Final Revised
Environmental Impact Report

Capitol Annex Project

State Clearinghouse No. 2019049066

September 2023

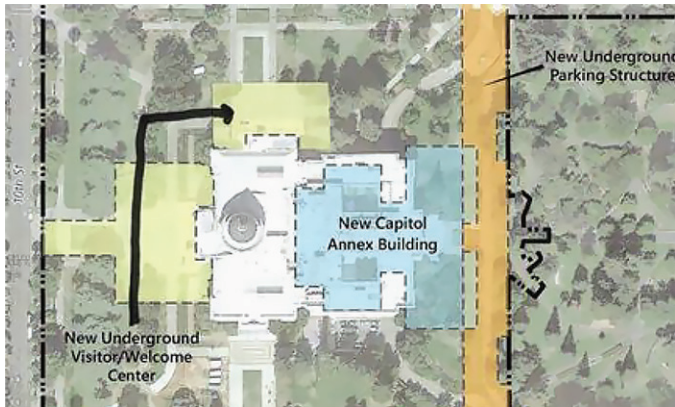
- Keeps 525,000 square feet of functional office and meeting space.
- Keeps the Double T building design so all offices have windows.
- Maintains same floor connections.
- Keeps Galleria entrance and view of 1870 Capitol dome, but reduces its width.
- Ensures Secretary of Interior's Standards met by using similar construction materials to historic Capitol and reducing Annex size.
- Incorporates historic Capitol's architectural rhythm of color, columns, windows to ensure integration of new Annex with existing surroundings.

As the commenter created the suggested alternative, it is assumed that the information on the size, shape, and characteristics of the proposed structure are accurate. An evaluation of the interior configuration of the offices and other facilities would need to be conducted to evaluate whether all offices would have windows. It is clear from the images provided in Comment O5-1 that any offices with windows under the commenter's proposal would have less access to natural light than under the proposed project. A detailed analysis would be required to assess whether the proposal would meet SOIS; however, such an analysis need not be conducted as part of this REIR (see Response O5-1). Based on a very cursory evaluation it does not seem like the proposal incorporates columns as indicated in the last bullet item.

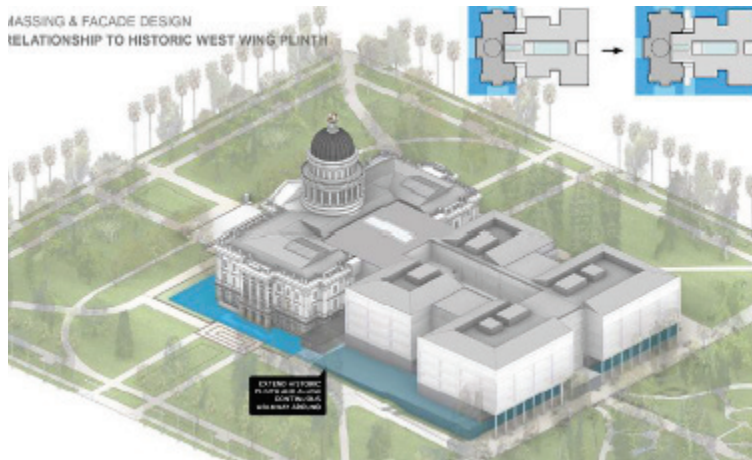
The meeting and gathering area for large events is necessary to promote the democratic processes.

Proposed New Visitors Center at the Main West Entry eliminates public gathering on a large scale. It also provides a 280-foot ramp with high terraced sides not usable by the public for large events.

The 2020 Recirculated Draft EIR and Draft REIR both recognize the visitor/welcome center's contribution to the significant unavoidable impact on the Capitol Complex. The comment provides information that aligns with the content of the Draft REIR. Please also see Master Response 2.

Proposed New Glass Annex

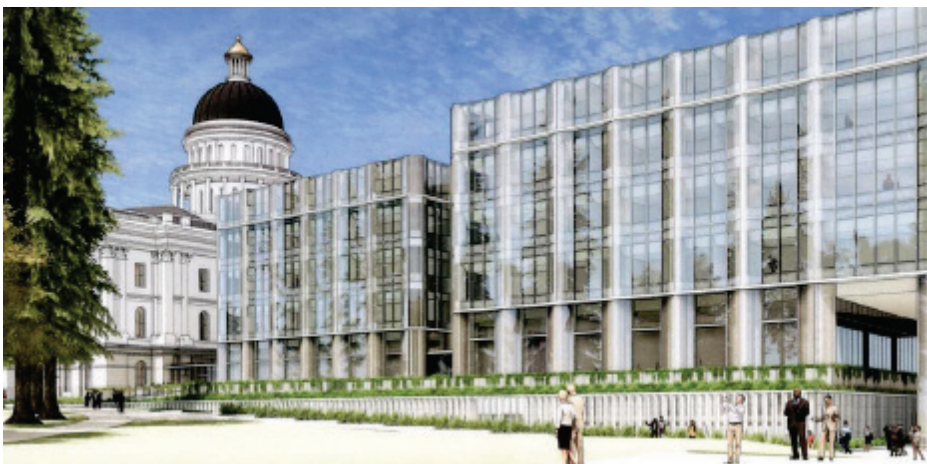
The new Annex disrespects and overshadows the iconic dome with its large size and reflective glass facade. It denigrates the most important historic governmental landmark in California. The new Annex is substantially over size for the existing historic Capitol and results in the diminution and loss of the historic character of the Capitol. The edges of the new Annex stick out beyond the footprint of the Capitol making the new Annex superior and overbearing to the Capitol.

The proposed new Annex greatly impacts the east, north and south elevations of the 1860-1874 Capitol by introducing a large reflective glass structure and the historic Greek Revival style of the historic Capitol. The new proposed Annex also is one story higher than the existing historic Annex and impacts the historic 1874 Capitol dome.

The new addition is significantly different in terms of materials (granite, concrete and stucco versus reflective glass), openings (no defined openings are visible compared to the window and doorway openings of the historic Capitol), the architectural rhythm of the colonnades, and the horizontal lines and the roofline that define the Capitol. The large glass facade is so foreign to the materials and openness of the historic Capitol that it is significantly different and incompatible. The large glass structure is not consistent with the architecture and stature of the original Capitol.

Each of these design aspects of the proposed Annex are analyzed against the SOI Standards in the discussion of Impact 4.12-4 in the Draft REIR (pages 4.12-20 through 4.12-23). As shown in Figure 4.12-3, the proposed Annex will be the same height as the top of the parapet on the Historic Capitol. The effect will be that the proposed Annex will appear to be the same height as the Historic Capitol and will not overshadow it in any way. In the same way that the Historic Capitol sits below and supports the capitol dome, the proposed Annex, which is the same height as the Historic Capitol, will sit below and appear subservient to the dome. As shown in Figure 3-3, the portion of the proposed Annex closest to the Historic Capitol has a footprint that recedes from the outer line of the footprint of the Historic Capitol and also has deeper recessions immediately adjacent to the historic building, both of which demonstrate the proposed Annex building’s subservience to the Historic Capitol. Figure 3-5, Double-T Perspective View, Looking North and Figure 3-6 Capitol Annex Double-T Design – Reveals Historic Capitol Eastern Facade illustrate how these recessions will allow portions of the east façade that have been obscured by the existing annex for decades to be restored and enjoyed by

The exterior treatment of the new Annex achieves compatibility and deference to the Historic Capitol with its use of horizontal and vertical rhythms that align with the Historic Capitol's exterior rhythms. The new Annex emulates the Historic Capitol's tripartite division of base, middle, and cornice where the pleated glass wall's glass parapet and shadow box aligns with the Historic Capitol's balustrade, a horizontal reveal aligns with the bottom of the Historic Capitol's cornice, and the lowest stack joint aligns with the Historic Capitol's water table (see Figure 4.12-3 and Figure 3-5, bottom image). Similarly, the Historic Capitol's strong vertical rhythm established by the use of Classical columns and the stacked alignment of large windows is emulated by the stone shadow box at the base and white ceramic frit coating in the glass above those shadow boxes that will give an appearance of a curved protrusion that will evoke the columns and pilasters on the Historic Capitol (see Figure 4.12-3).

It should be noted that the figure provided in the comment with the caption "Proposed New Glass Annex" shows an older Annex design and does not show the trees that would be present after project implementation. The two figures at the end of the comment are reproductions of images provided in the Draft REIR and are a more accurate representation of the new Annex's appearance.

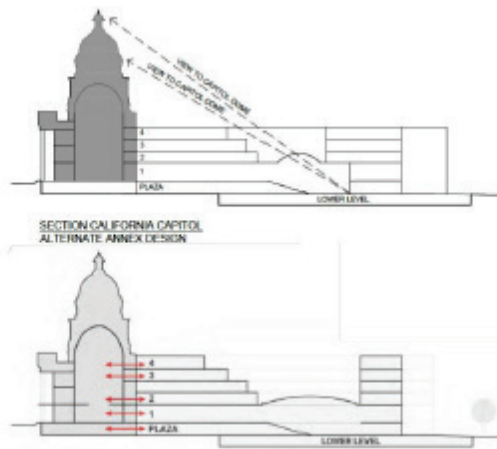
- *Designing new construction on a historic site or in a historic setting that it is compatible but differentiated from the historic building or buildings.*
- *Ensuring that new construction is secondary to the historic building and does not detract from its significance.*

The Capitol View Protection Requirements, Sacramento Zoning 17.216.860 C-3 protects The State Capitol building and the surrounding grounds of Capitol Park by establishing height restrictions, setback requirements, and parking regulations for certain areas of the CBD located near the State Capitol building and Capitol Park. These regulations are designed to provide visual protection to and from the Capitol building and Capitol Park as well as setbacks.

The comment references the Capitol View Protection Act, duplicates images from the Draft REIR, and provides a new image related to the Annex alternative presented in Comment I21-8. The comment does not address the content or analysis in the Draft REIR. The Capitol View Protection Act is described in the Draft REIR in Section 4.15.1, "Regulatory Setting." As identified there, "The Capitol View Protection Act does not provide height restrictions or other limitations in Capitol Park (Figure 4.15-1). For this reason, the project would not be required to comply with the Capitol View Protection Act." (Draft REIR page 4.15-3)

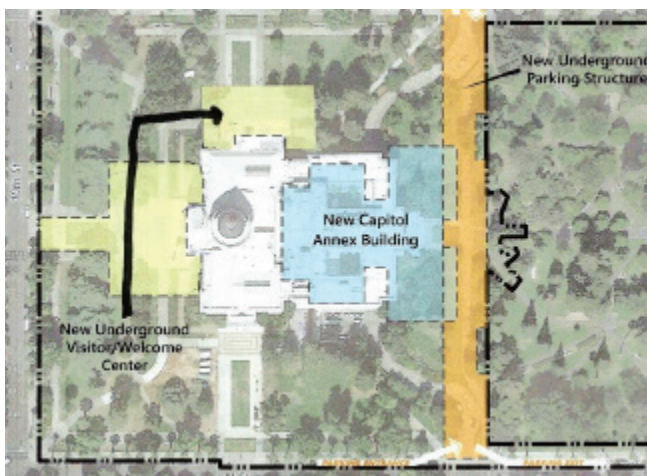
The Revised Draft EIR offers reasons as to why Alternative 5 “Visitor/Welcome Center South Entrance, page 7-13 cannot be accomplished. The reasons do not stand scrutiny. The RDEIR considers the proposed footprint of the western location of the Visitor Center with its extremely long down ramp entrance and alleges that neither the north nor south locations is far enough from L or N Street to accept the long downward ramp. However, the distance from the outside face of the granite porticos to the street is substantially the same on the north, west, and east facades of the 1860’s Capitol. So the fit of the ramp should be substantially the same.

Moreover, the analysis does not but should consider alternates to the ramp entrance. Since the protected west view corridor would not be affected by either a north or south visitor center location, the use of stairways and elevators such as those proposed in the recirculated Draft EIR of January 2020 could be used taking only 60 feet of distance. There is more than enough room for such an entrance on either the north or the south side of the Capitol.
